DESIGN & ACCESS STATEMENT

Manor Lodge
Rickmansworth Road
Northwood
Middlesex

Demolition of the existing structures and creation of 6 family residential units together with means of access and associated parking and landscaping.

PRE-APP SUBMISSION

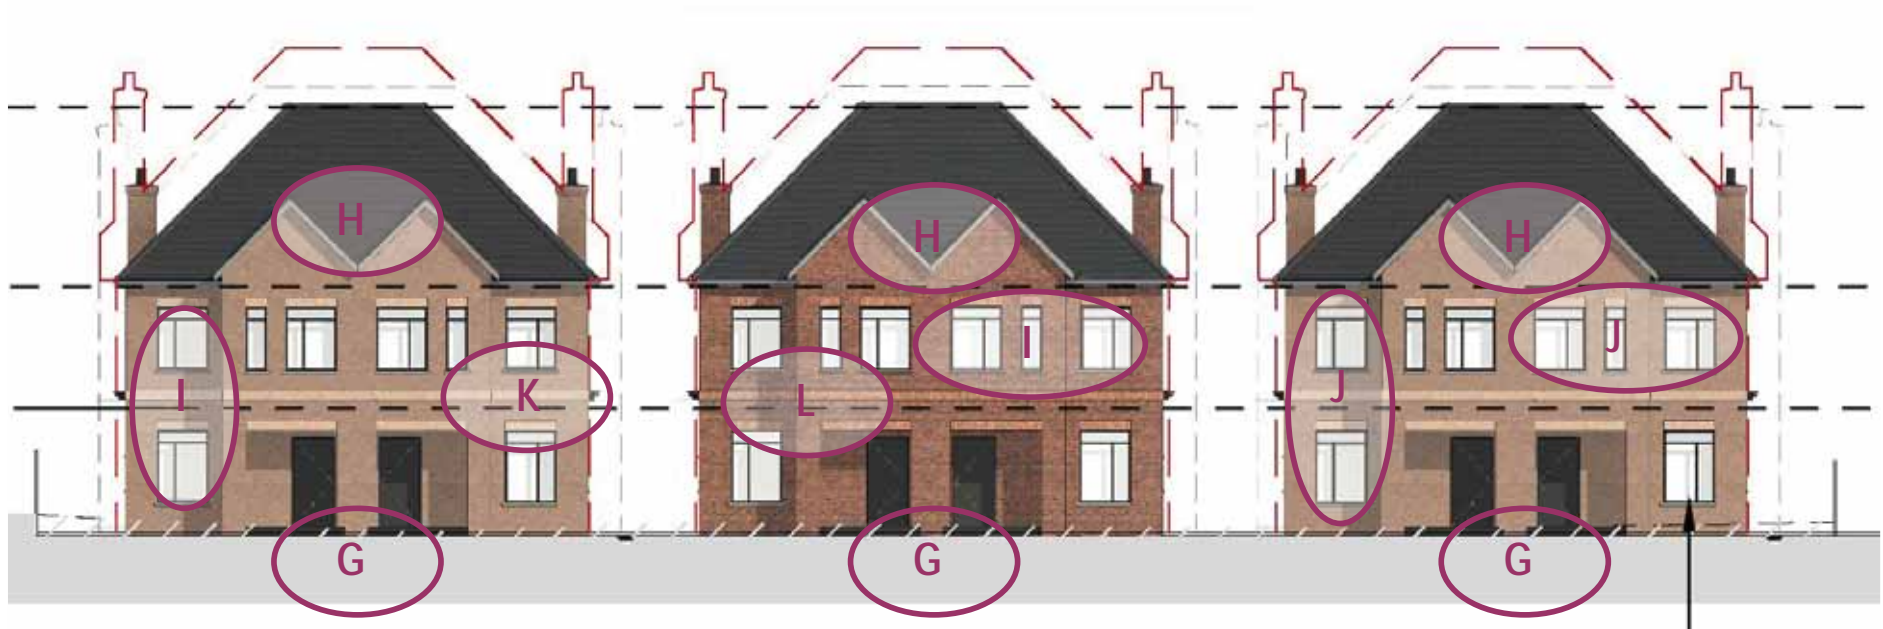
| In terms of facade articulation, concerns were raised over how the proposed front elevation lacks gesture and reads as too simple. | | <p>The following changes have been made in terms of materials and elevational treatment to provide visual relief and enhance visual interest:</p> <ul style="list-style-type: none"> • Full brick façade introduced (G); • The previously proposed large central front gable has been reduced in size and split into two smaller gable ends (H); • Fenestration has been broken up for visual relief and all windows and doors are now of a more contemporary style (I); • Consistent fenestration proportions on ground and first floor (J); • Subtle variation in brick coursing and detailing (K); and • The middle building is of a darker brick colour which provides a subtle change across the three buildings (L). |
